**TOWN OF MOUNTAIN VILLAGE
DESIGN REVIEW BOARD REGULAR MEETING
THURSDAY OCTOBER 1, 2015, 10:00 AM
2nd FLOOR CONFERENCE ROOM, MOUNTAIN VILLAGE TOWN HALL
455 MOUNTAIN VILLAGE BLVD, MOUNTAIN VILLAGE, COLORADO
AGENDA
REVISED**

3.	10:05	30	Jameson	Action	Consideration of a Design Review Process Development Application for new construction of a single-family residence on Lot BC513AR

**PLANNING AND DEVELOPMENT
DEPARTMENT**

PROJECT NAME: DENESIK RESIDENCE MOUNTAIN VILLAGE, COLORADO 81435	PROJECT NAME: MOUNTAIN VILLAGE
SHEET DESCRIPTION: OVERALL SITE PLAN	SHEET NUMBER: A-100

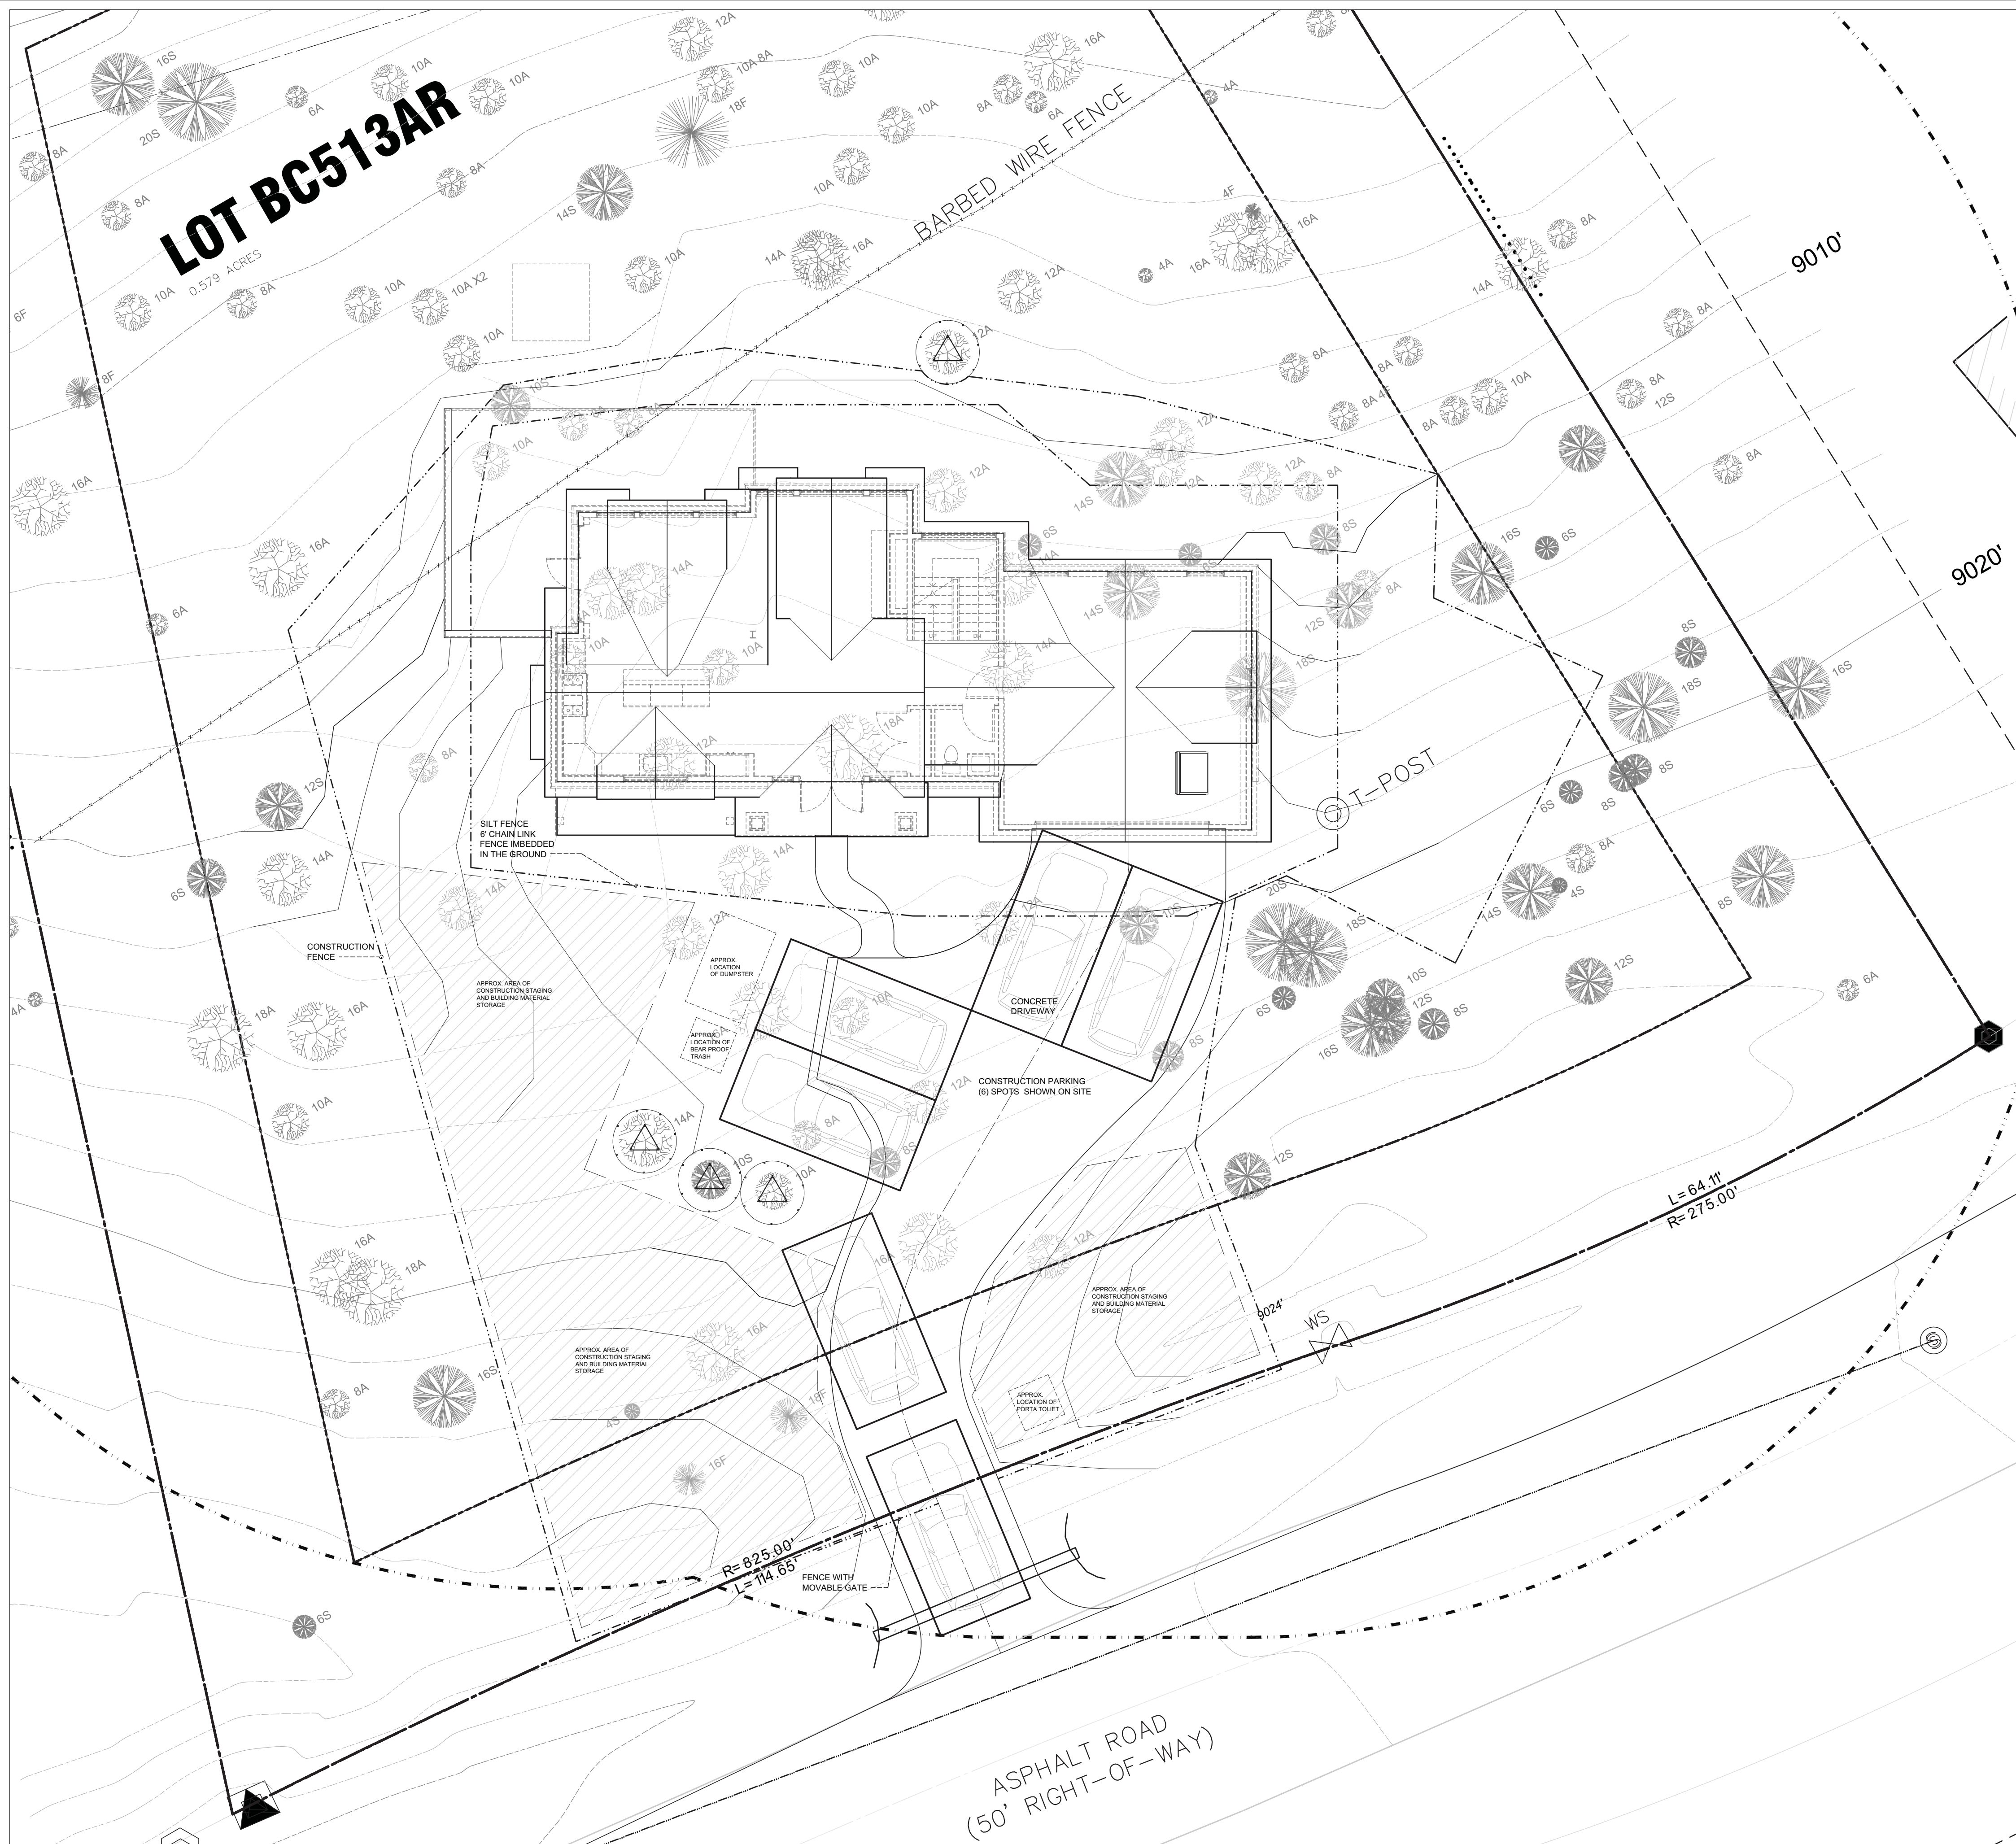
The DRB should review the site plan and determine whether the construction staging encroachments into the General Easements would cause unreasonable negative impacts to the surrounding properties.

LANDSCAPE AND EXTERIOR LIGHTING

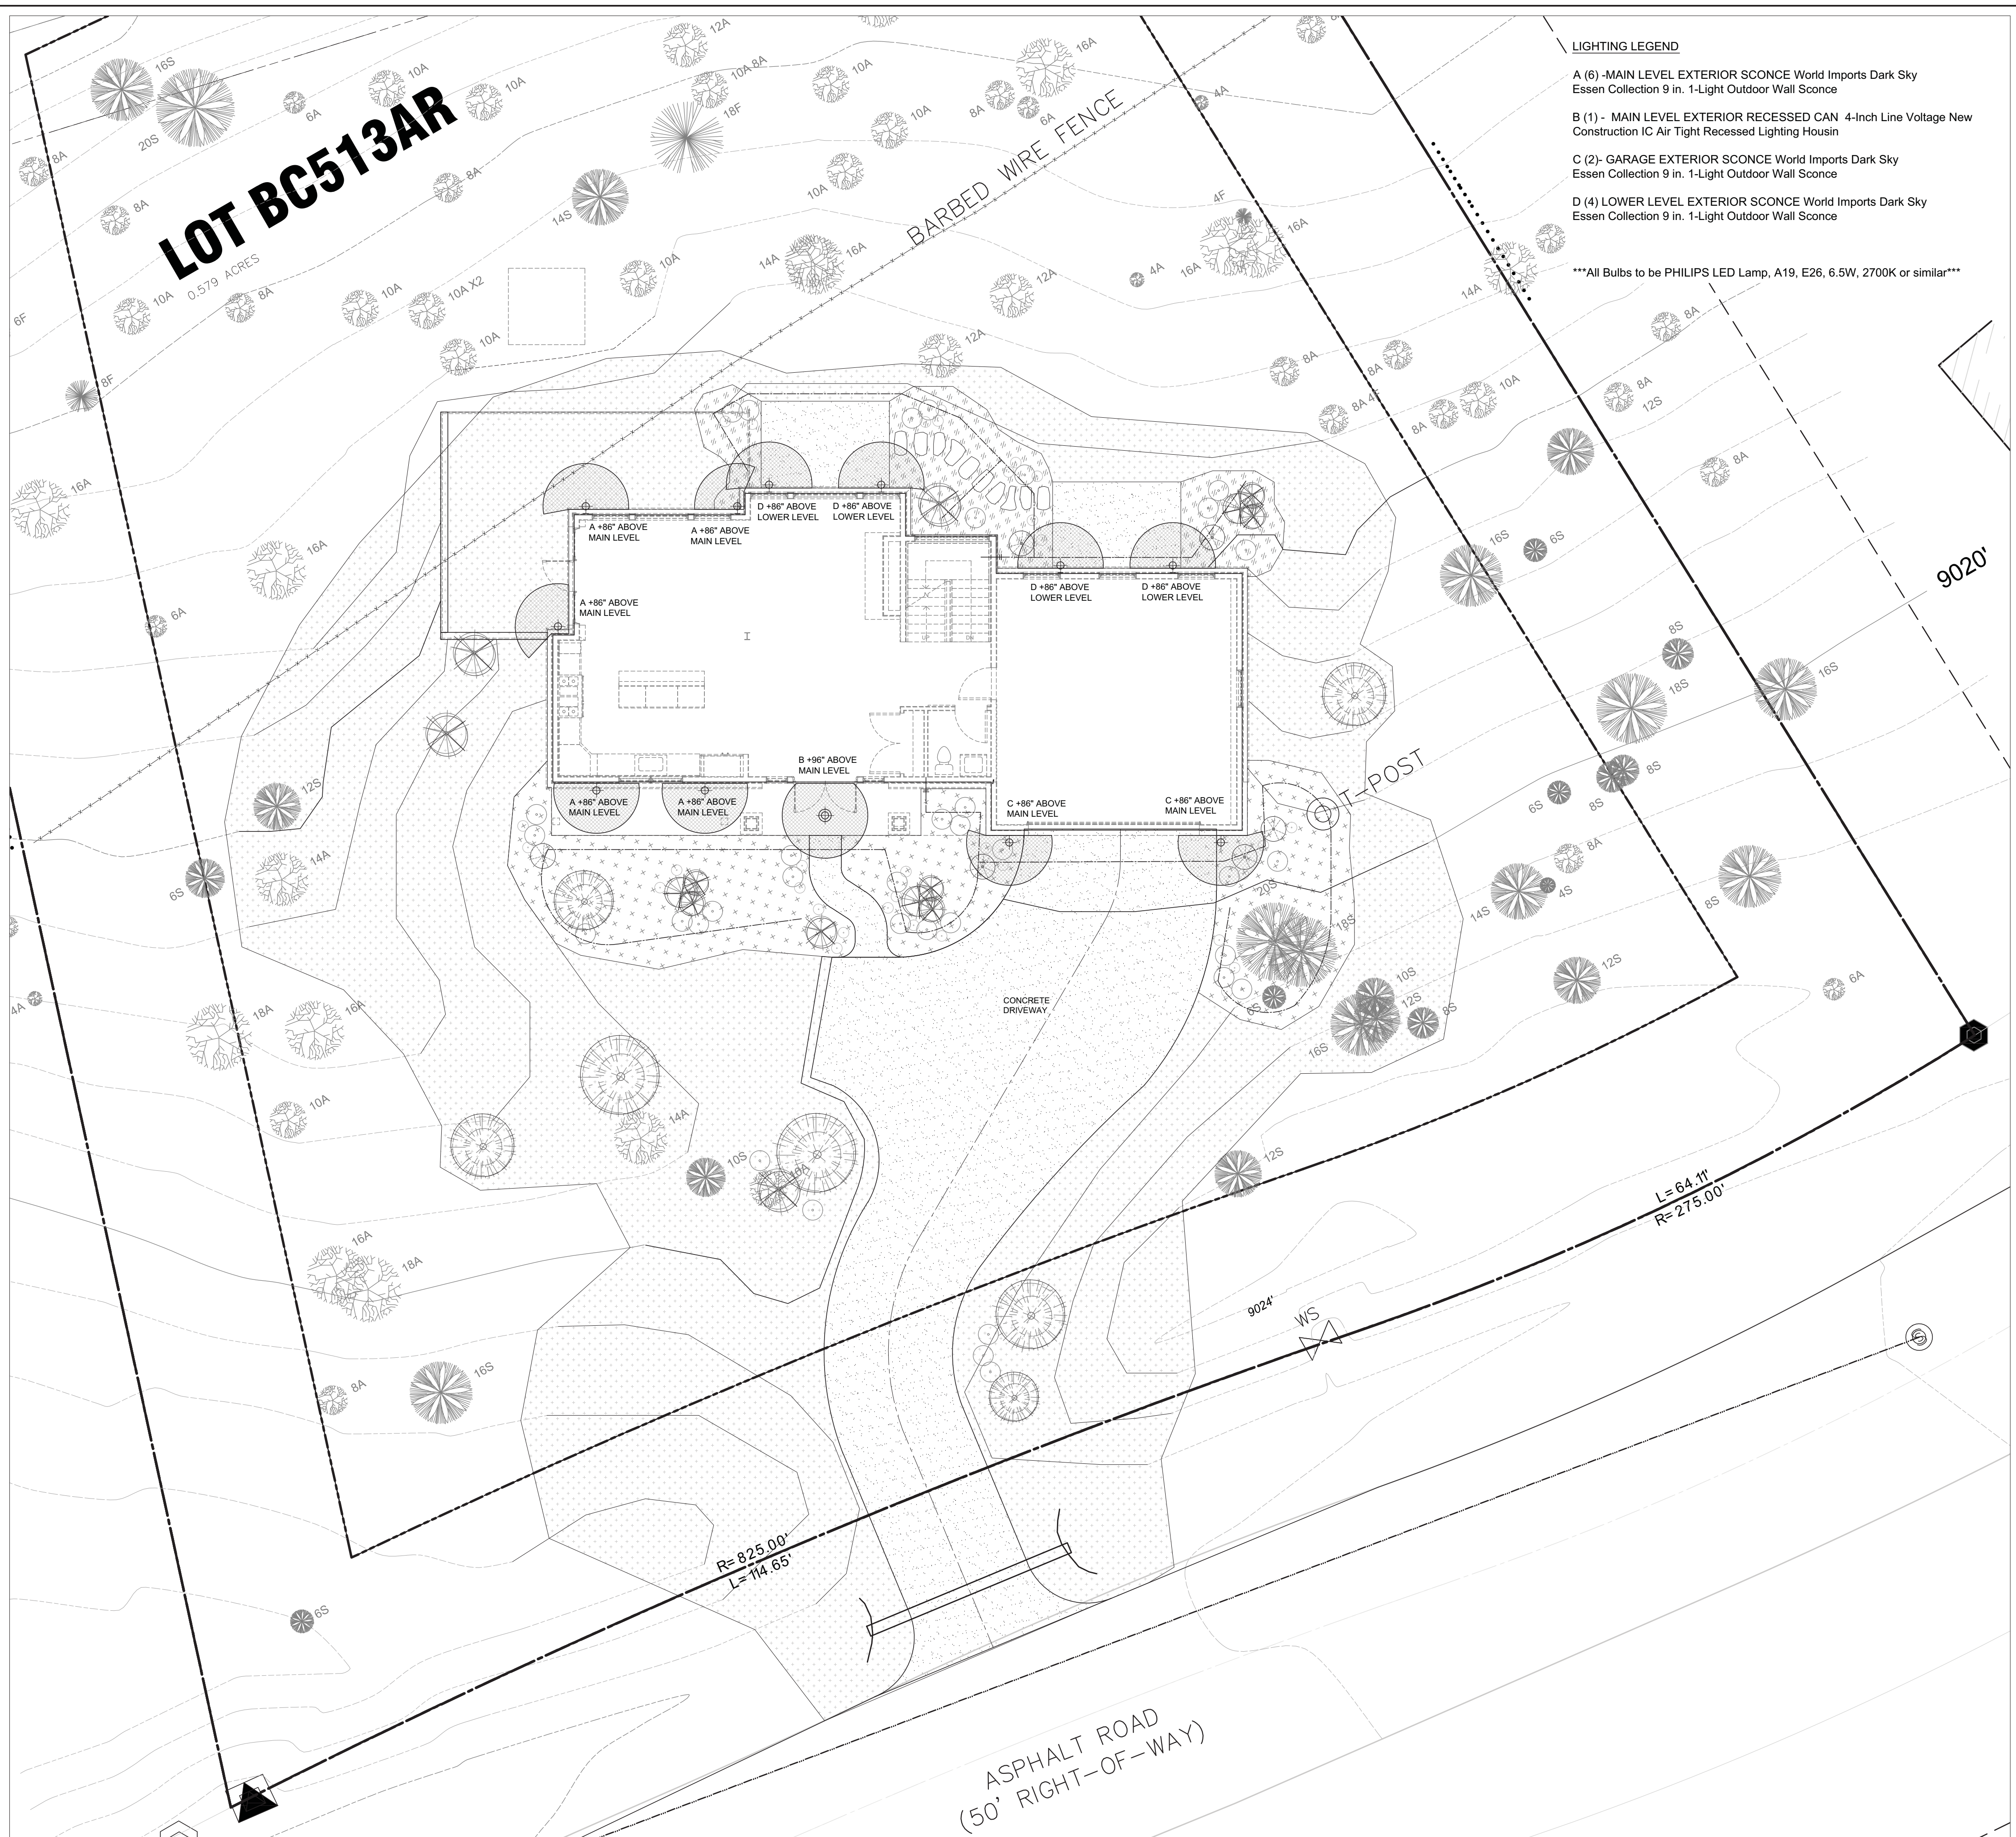
The proposed landscape plan shows (8) aspens and (7) fir to be planted, in additions to a mixture of shrubs and perennials. All plantings shall be in compliance with Table 5-4 of the CDC:

The proposed lighting plan includes one (1) recesses can light and four (12) sconces. Locations include egress, and deck and patio areas. Lighting is permitted in all proposed locations. All lighting has been designed as full cut-off fixtures with LED bulbs. Kelvin temperature has not been specific and staff recommends a condition of approval to limit the temperature to be 3,500K or less.

SHEET DESCRIPTION:
ROOF PLAN

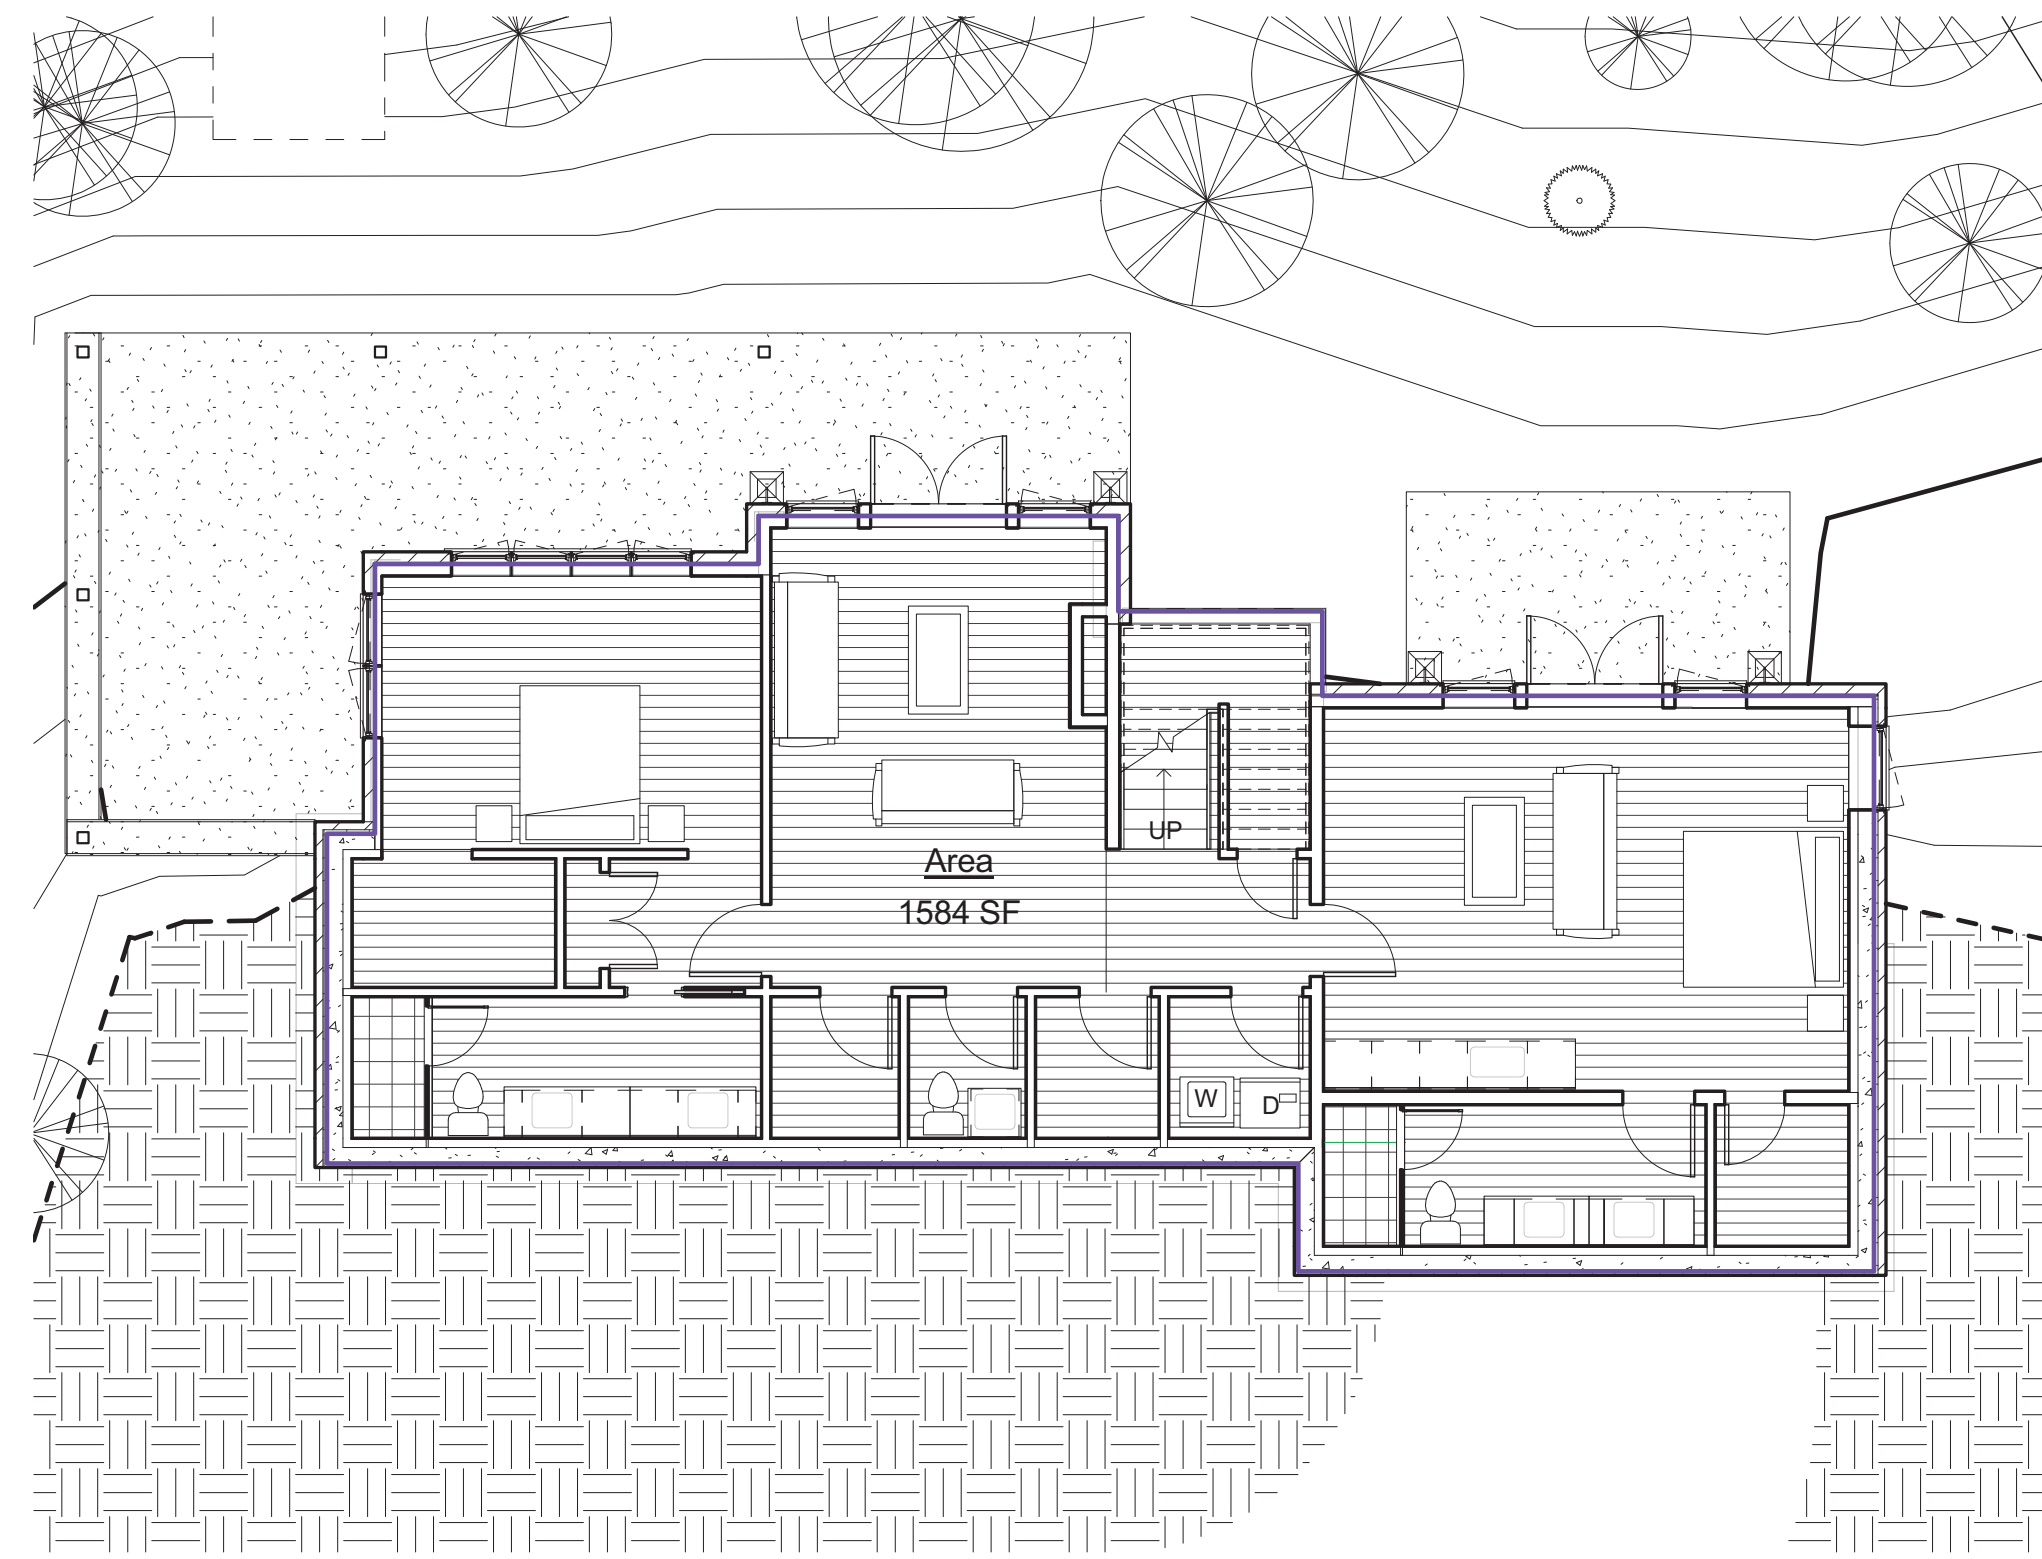
The CDC allows for primary roof pitches to be between 6:12 and 12:12 and be gable in form, and secondary roofs will not have pitches less than 4:12 and be either gable or shed in form. With this in mind, the roof plan illustrates that a shed roof adjacent to the entry will have a 3:12 slope, requiring a variance. All other roof slopes are compliant.
